**Project #21-070
Gateway Apartments
Located at approximately 721 South 100 West**

<i>Project Name:</i>	Gateway Apartments
<i>Proponent / Owner:</i>	Jeff Douglas / Craig Adams
<i>Project Address:</i>	721 South 100 West
<i>Request:</i>	Design Review Permit
<i>Current Zoning:</i>	Mixed Residential High (MR-30)
<i>Type of Action:</i>	Quasi-Judicial
<i>Hearing Date:</i>	December 9, 2021
<i>Submitted By:</i>	Russ Holley, Senior Planner

RECOMMENDATION

Figure 2 shows the proposed site plan.

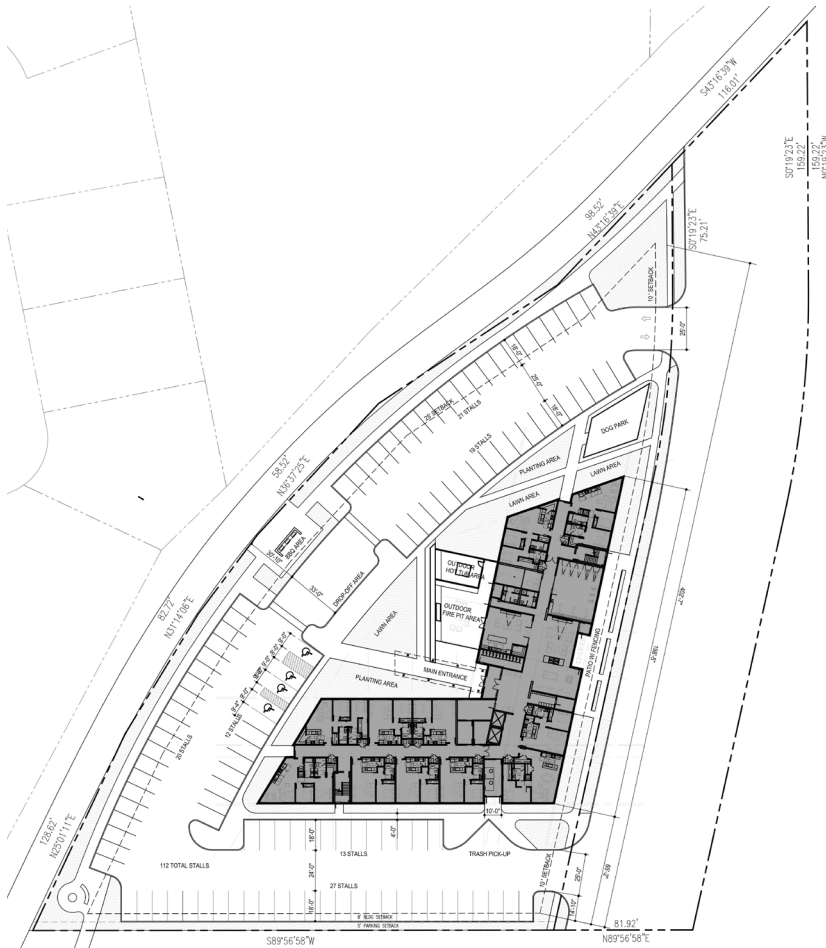
The LDC 17.7.100 establishes a maximum lot coverage of 60% (building(s) footprint in relation to overall lot size) and a minimum building frontage of 60% (percentage of building width to overall lot width at front setback) in the MR-30 zone. The submitted project shows a lot coverage of 26% and a building frontage that equals approximately 50%. The building frontage does not meet the minimum of 60% as submitted. The Planning Commission may use discretion as per LDC 17.43.080.C.5 and consider the unique shape of the site due to the river and the proximity of the proposed 100 West road extension and bridge in determining appropriate building frontage adjustments on this property. As conditioned with building frontage compliance, the project meets the requirements in the LDC.

The LDC 17.09.040 requires multi-family buildings to have minimum variations, interesting façade design, a mix of materials and articulation for aesthetically pleasing projects. The code requires building orientation that creates inviting architecture from the street, surface parking lots located in subordinate locations and prominent and convenient pedestrian circulation for better walkability. The proposed project shows brick, glass, cedar, stucco and metal building materials and articulations that provide variation and emphasize orientation. The site plan shows sidewalk connections to 100 West and the new trail along the river. As proposed, the project meets the building design requirements in the LDC.

3. Building frontage along 100 West shall be at least 60% unless the Planning Commission adjusts the standard as per LDC 17.43.080.
4. The Community Development Director accepts the alternative parking plan of 112 stalls as proposed (less than 15% reduction). If any deviations occur prior to project completion, a second review and approval is required. Cross access and cross parking agreements shall be recorded on each affected property title in accordance with this proposal and cannot be removed unless approved by Logan City. Bike parking/racks shall be provided onsite.

6. A building entry and sidewalk connection shall be made on the east façade providing convenient pedestrian connections to the street.
7. All pedestrian entrances shall have weather protection provided above.
